PJM Manual 14D:

Generator Operational Requirements

~~Revision: 59~~ Revision: 60

Effective Date: ~~September~~ October 1, 2022

Exhibit XXX. An example of real-time data and account metering requirements for a Mixed Technology Facility, including measurement points. This facility is 75 MW or larger and

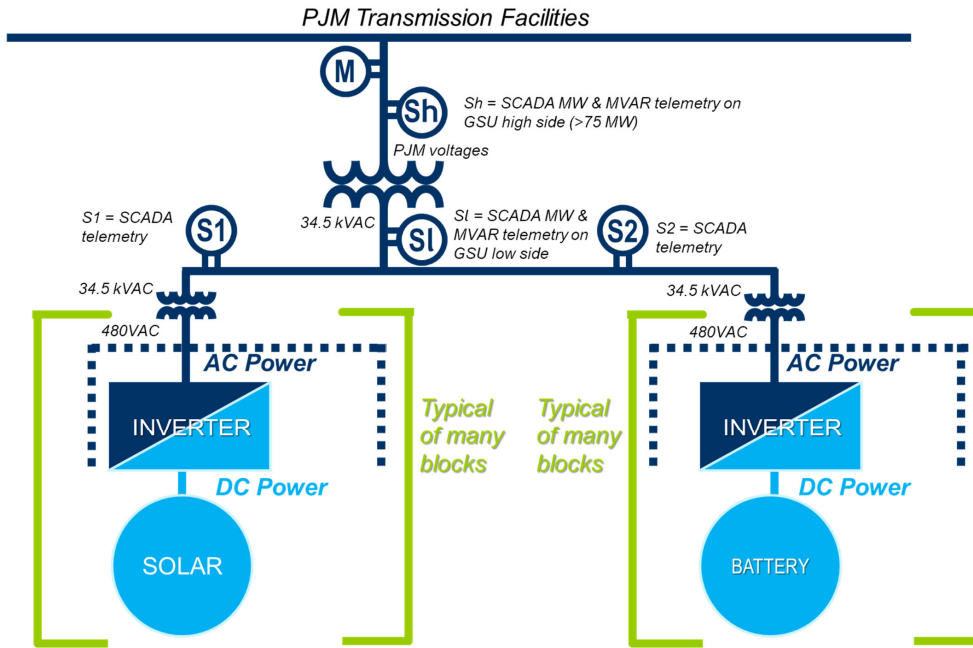
A Mixed Technology Facility shall have metering that measures non-real-time or revenue information corresponding to the Point of Interconnection (shown as "M" in Exhibit XXXX below). This metering shall meet the accuracy requirements for primary billing metering systems specified in Manual 01 section 5.3.2 (or other section of that manual as may be applicable). A Mixed Technology Facility participating in markets as multiple Co-Located Resources requires non-real-time MWh revenue information for each Co-Located Resource. Such MWh quantities may be calculated by apportioning the MWh measured for the entire Mixed Technology Facility across the Co-Located Resources. Such apportionment may be achieved pro rata based on the real-time MW telemetry for each Co-Located Resource.

Exhibit XXXXX below illustrates an example of a Mixed Technology Facility with a solar resource and an Energy Storage Resource, each participating separately in markets as a Co-Located Resource. In this example, all of the energy measured for the Mixed Technology Facility at "M" across an interval (e.g., 5 minutes) is split between the solar resource and the Energy Storage Resource pro rata according to the power measured at S1 (which measures all of the solar production) and at S2 (which measures all of the storage power flows) integrated over the interval.

Section 13: Mixed Technology Facility Requirements

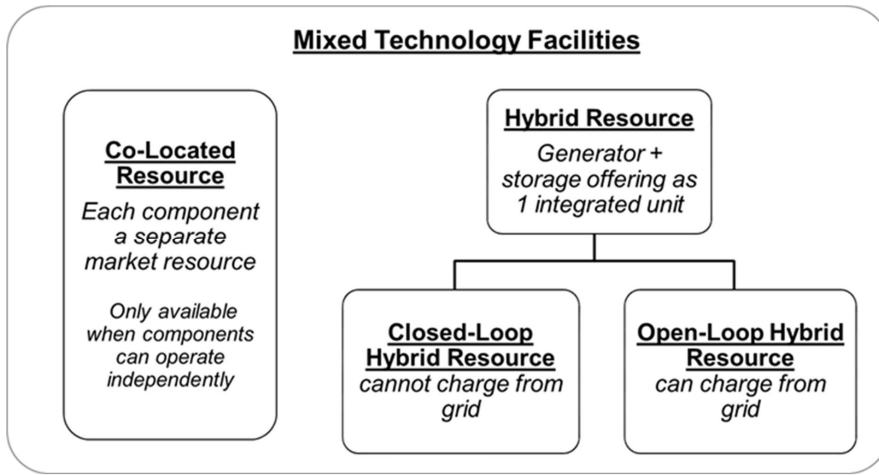
This section provides additional requirements specific to Mixed Technology Facilities. Mixed Technology Facilities are Generating Facilities and must follow all other requirements for Generating Facilities outlined in this manual and elsewhere.
